Rezoning Transportation Analysis

Petition Number: 2020-068

General Location Identifier: Tax ID. 17514688

Date	Description
05-18-2020	First Review

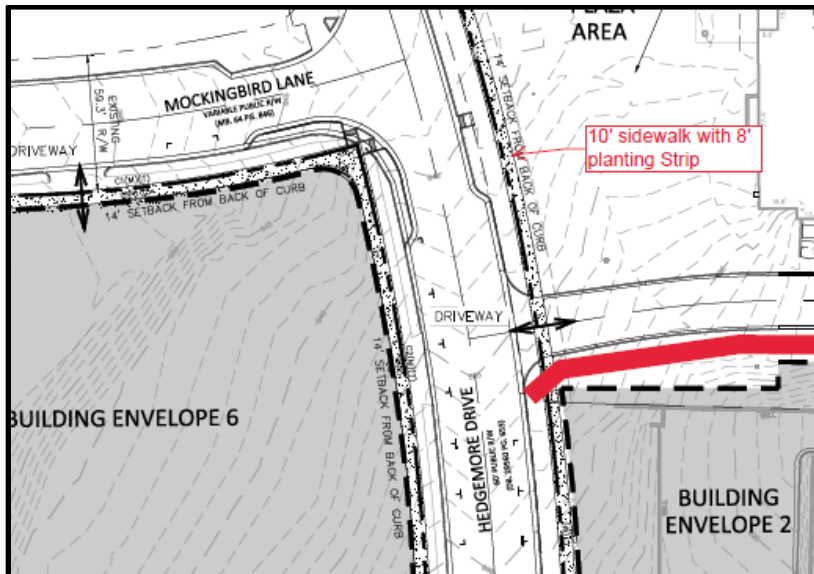
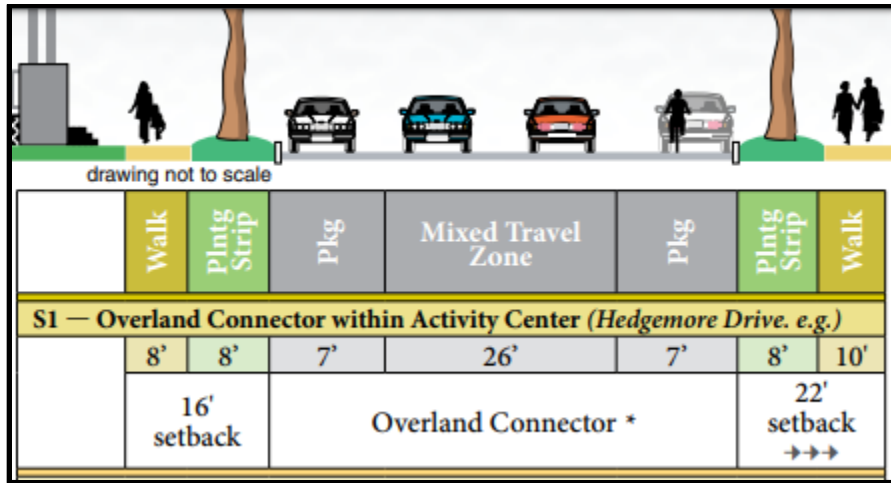
- Traffic Study** A Traffic Impact Study is necessary for the complete review of this petition due to the site generating more than 2500 daily trips.

Staff will receive the petition and begin work on it, but the public hearing will not be scheduled until the TIS is received. This will allow for the minimum time necessary for CDOT to review and approve the study and reach agreement with the petitioner on the required transportation commitments, and have them included on the last site plan submitted no fewer than 4 weeks prior to the public hearing. Therefore, additional traffic mitigation comments may be forthcoming once the TIS is approved by CDOT and NCDOT.

- The petitioner should revise the site plan and conditional note(s) to commit to constructing an 8-foot planting strip, and a 10-foot sidewalk on Hedgemore Drive per the Park Woodlawn Area Plan. The site plan should label and dimension both items from the back of curb and gutter to the road centerline.

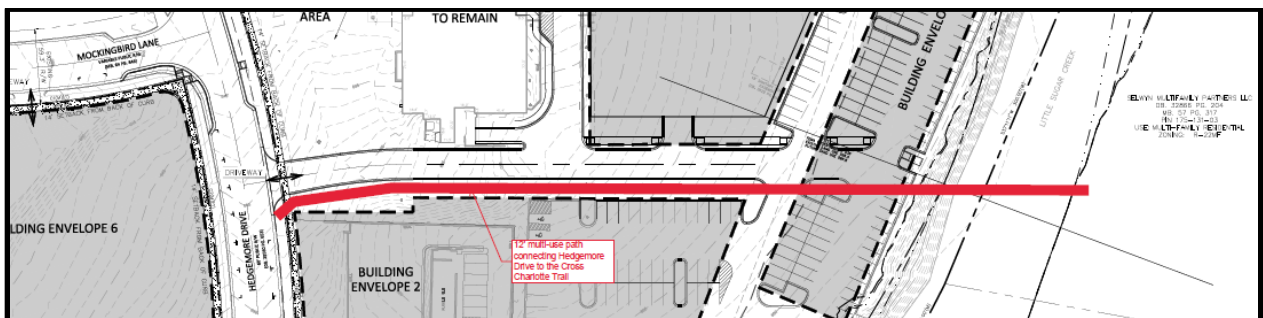
- CDOT requests that the petitioner revise the site plan and conditional note(s) to commit to a 12' multi-use path connecting Hedgemore Drive to the Cross Charlotte Trail (XCLT) including a pedestrian bridge over Little Sugar Creek east of the site, to meet the City of Charlotte BIKE Policy. CDOT also requests a public access easement with parking and a trailhead to the XCLT as a Traffic Demand Management (TDM) measure.

S2 — Other Local Streets within Activity Center						
8'	8'	7'	26'	7'	8'	8'
16' setback		Office/Commercial - Wide			16' setback →→→	
S3 — Local Streets within Wedge Neighborhoods

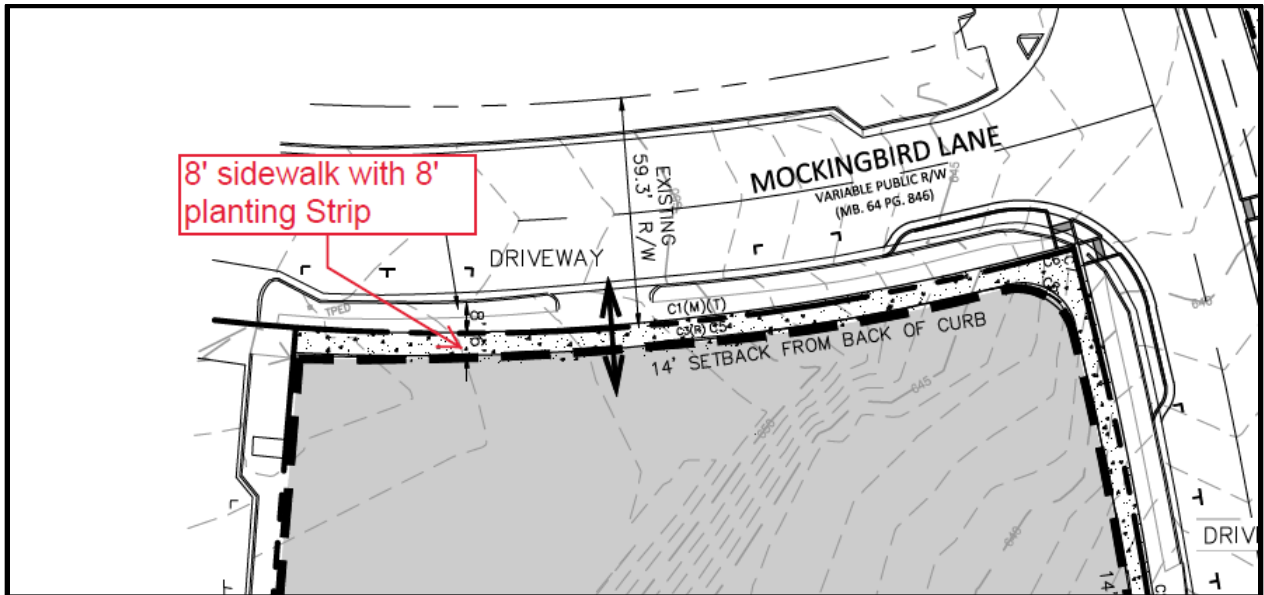
- The petitioner should revise the site plan and conditional note(s) to commit to constructing an 8-foot planting strip, and an 8-foot sidewalk on Mockingbird Lane per the Park Woodlawn Area Plan. The site plan should label and dimension both items from the back of curb and gutter to the road centerline.
